**Calaveras County Water District
Copper Cove, California
Bidding Documents
Copper Cove Phase 1 and 2 Tanks Project**

**ADDENDUM NO. 2
Issued August 3, 2023**

COPPER COVE WATER SYSTEM IMPROVEMENTS PROJECT - PHASE 1 AND PHASE 2 TANKS

REV	DATE	FOR APPROVAL	COMMENT
0	1-14-82	CALMECO CORP	WEST COAST TANK CO.
CALAVERAS CO WATER DISTRICT			
COPPER COVE STORAGE FACILITIES COPPER COVE, CALAVERAS COUNTY, CALIF			
780,000 GAL STORAGE TANK PLAN & DETAILS

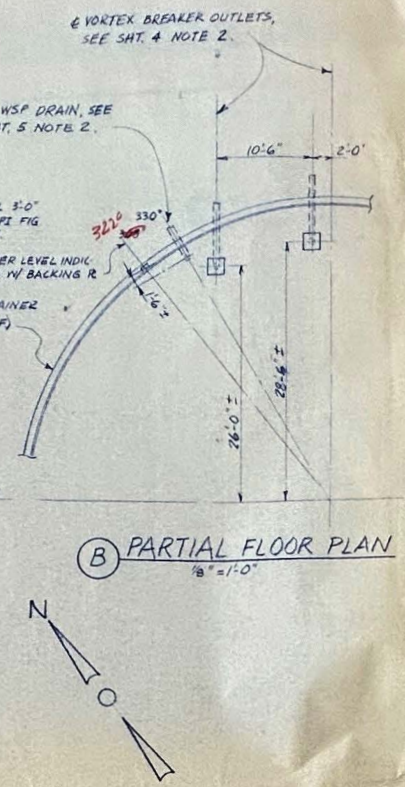
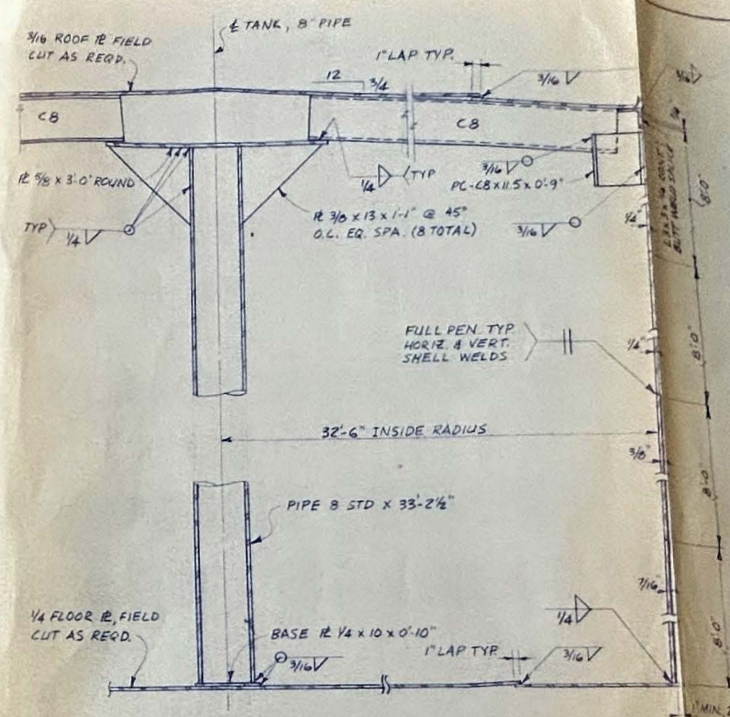
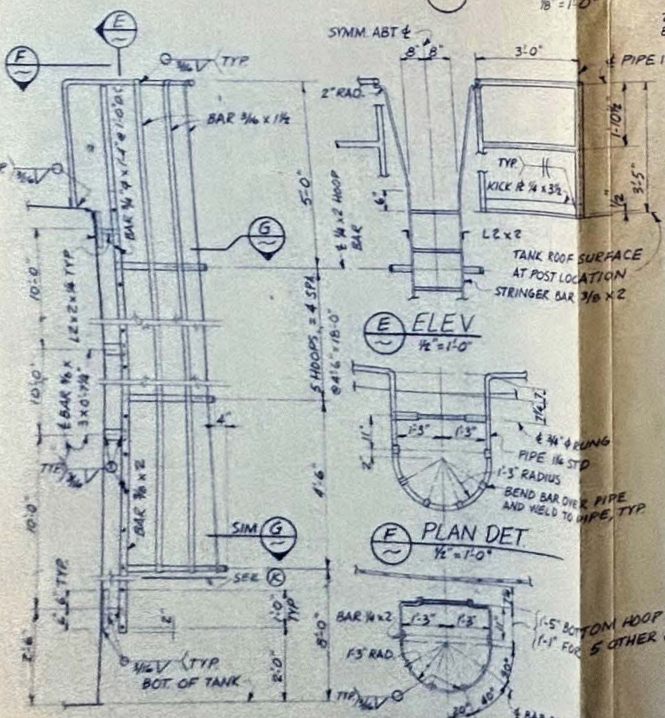
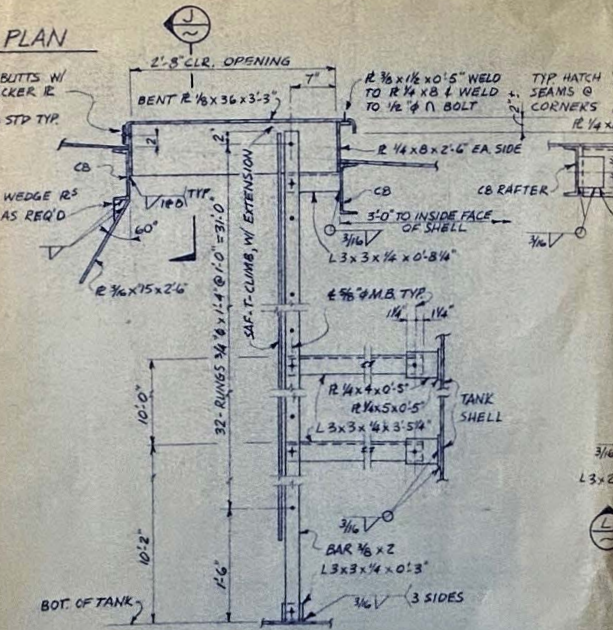
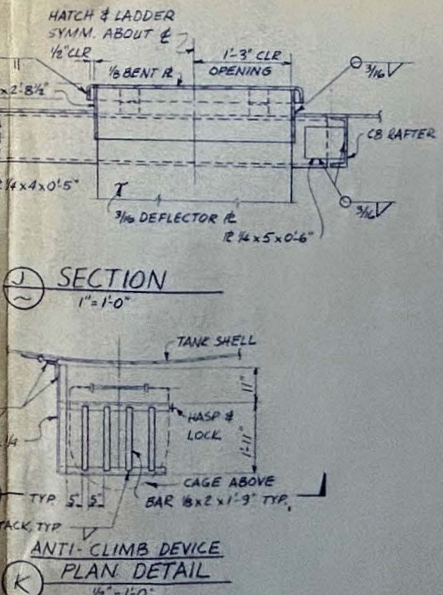
Question #5: Are there shop drawings for STL B tank?

Response #5: Yes, shop drawings for the existing steel B tank are added as Attachment C of this document.
